RE: Butte Priority Soils Operable Unit (BPSOU) Draft Final Revised Scrap H Road Work Plan

Draft Final Revised

Scrap H Road Work Plan

Response to Agency Comments to the Draft Final Scrap H Road Work Plan
Received on September 5, 2017
Prepared for Atlantic Richfield Company
By Pioneer Technical Services, Inc.
Dated September 14, 2017

SHEET
1 OF 8

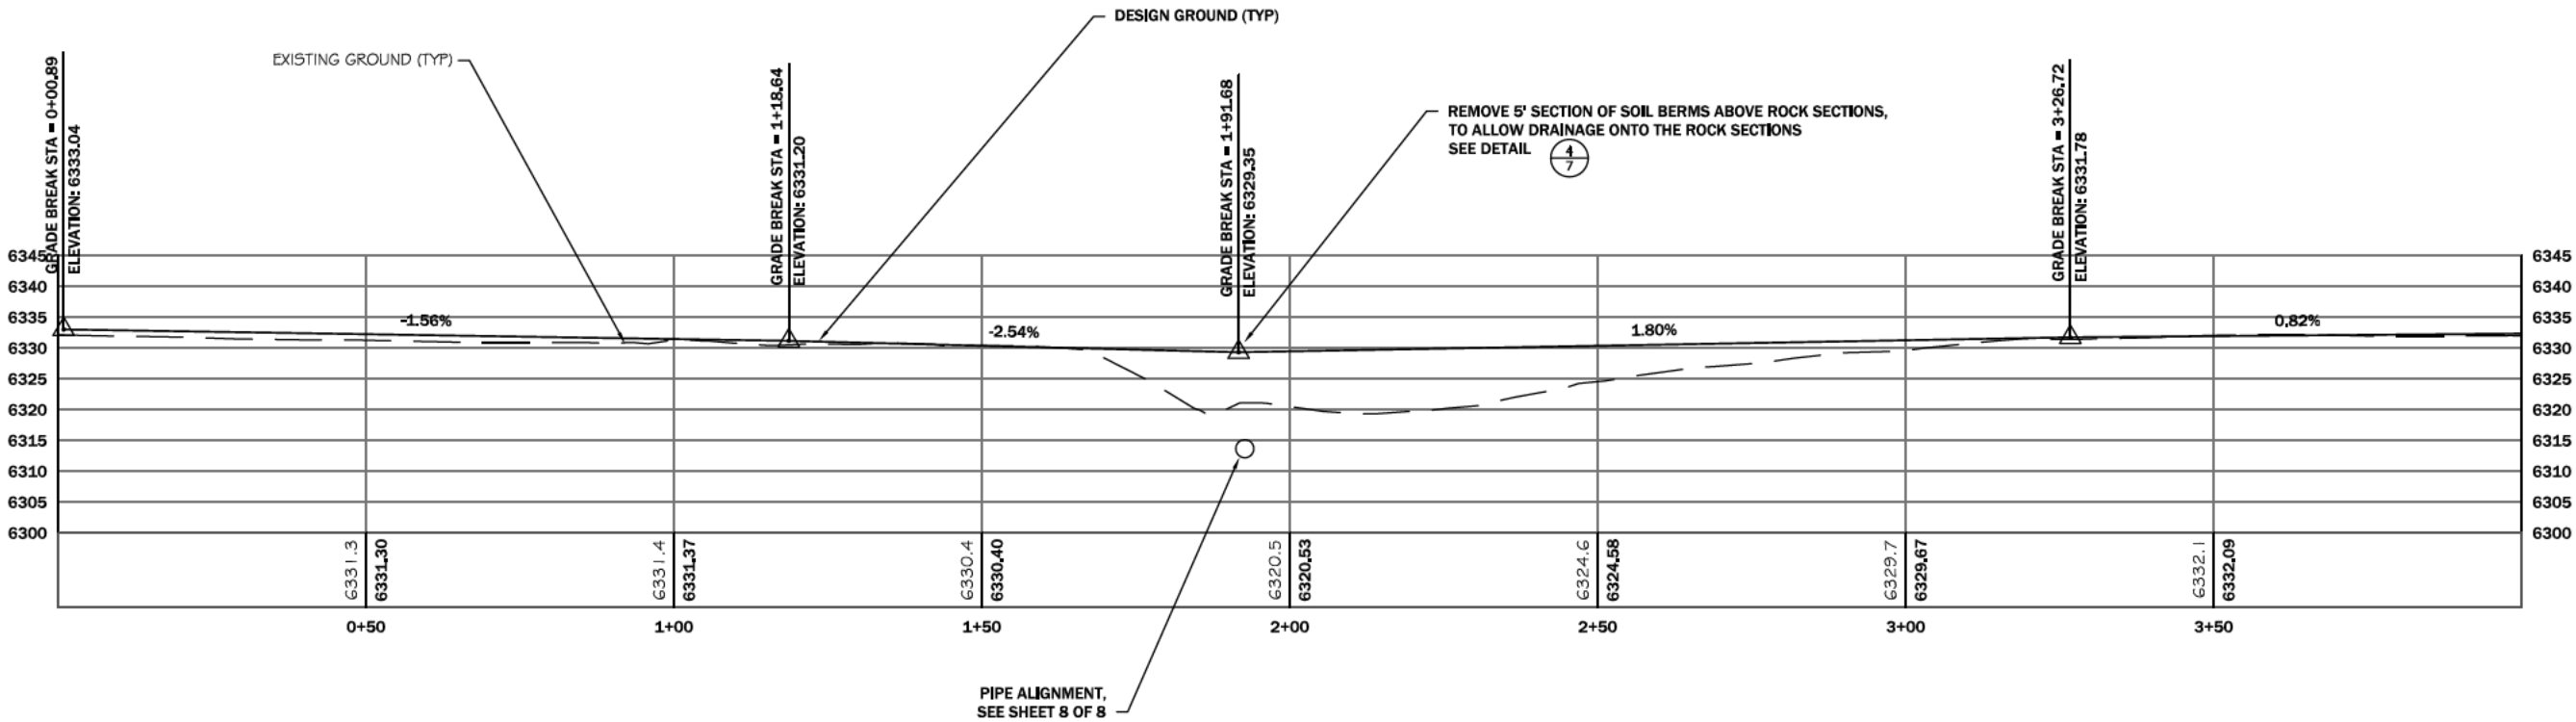
Sheet 1 of 8 plan view:

- a. The grading contours and existing contours are not labeled. Labels are needed to confirm grades and show correct tie-in to existing ground outside of the work area.*

- b. New grading layer shows the triangles from the ACAD model in addition to the grade contours. This clutter makes the entire drawing difficult to read, including the existing contours, stationing, etc. These triangles should be turned off for a final drawing to be used for construction.*

- c. Stationing along the road is provided, however, section lines that match the sections shown on sheets 3 to 5 are not indicated. Please add section lines to reference the cut/fill sections.*

- d. Callout 'Rock Section, See Sheet 8 of 8'. It is not clear where the rock section(s) is supposed to go based on where the arrows are pointing, and all the triangle clutter on the sheet. Please show clearly where the rock sections (channel) shall go on the plan view sheet. Also, clarify if this sheet should reference the 'rock section (south side)' detail on sheet 7?*

- e. Callout 'Riprap inlet, see detail 1, 7 of 8' is for the culvert inlet, but is referencing the detail for the riprap apron at the culvert outlet. Please clarify.*

For item a. labeled contours and item b., triangles have been turned off. For item c. section lines have been added. For item d., the triangles have been removed and the rock section detailed on sheet 7 of 8 is for both the north and south side. For item e., the detail has been clarified.

SHEET
8 OF 8

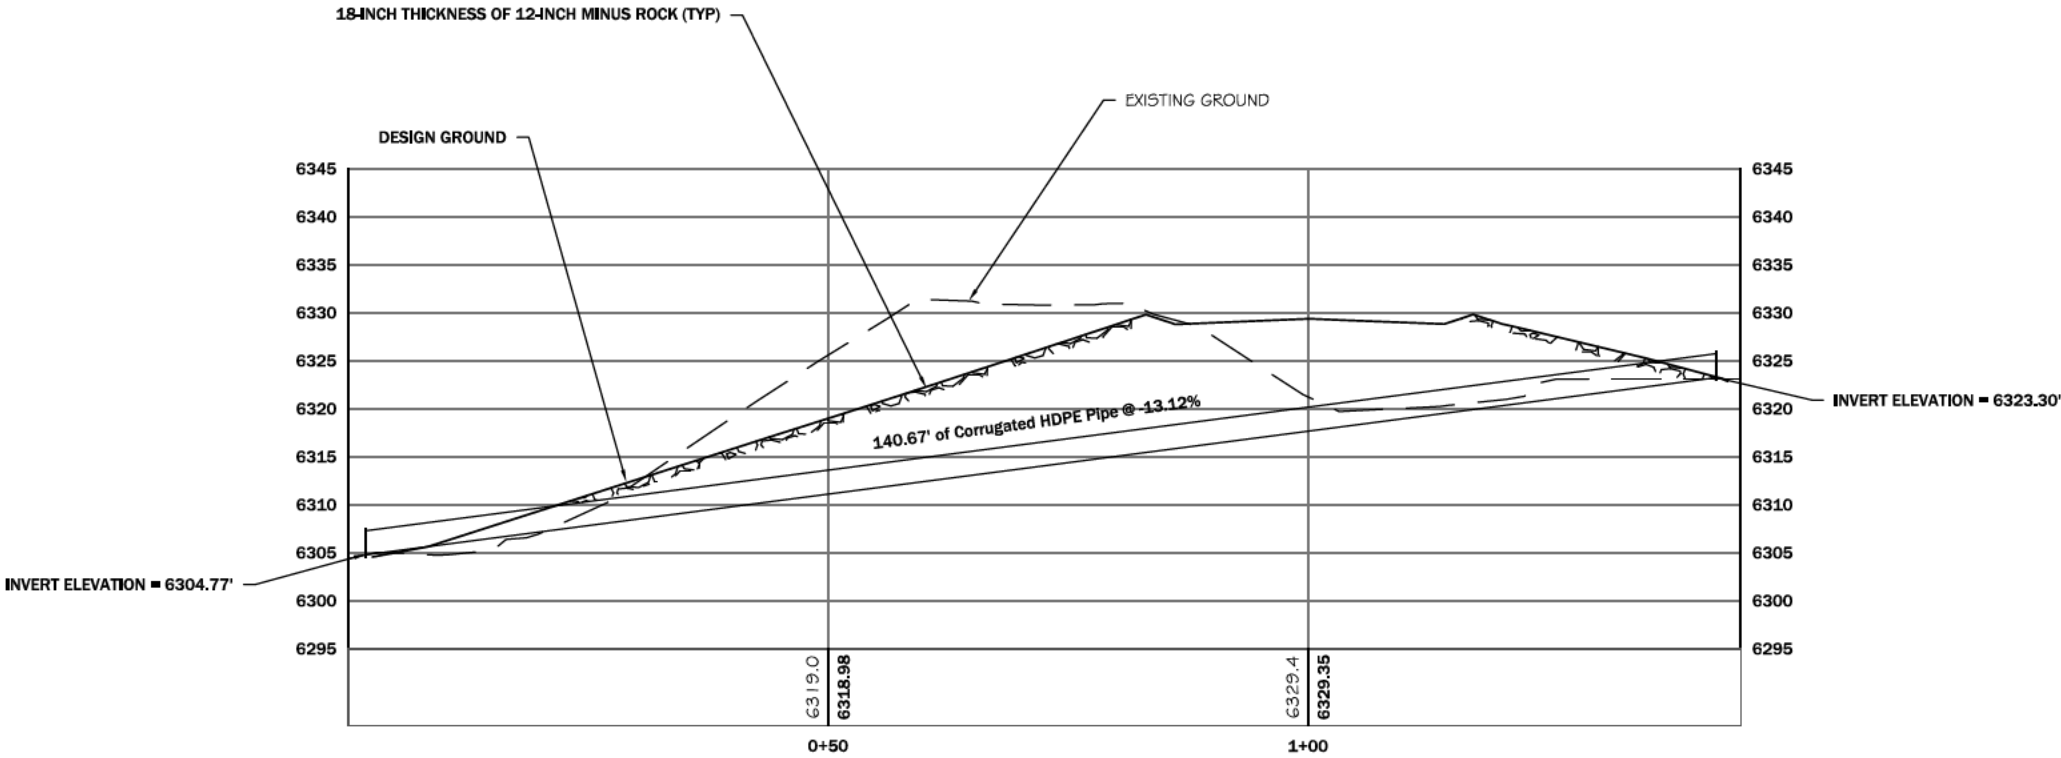
Sheet 8 of 8 culvert profile:

- a. The profile shows an 18-inch riprap layer over the pipe on the new graded surface. Shouldn't the surface be an 18-inch soil cover per specifications? Please clarify.*

The riprap section is aligned with the cutouts on the road berm to prevent slope erosion during storm events. The berm directs storm water to a single outlet to prevent the area rilling on the south slope.
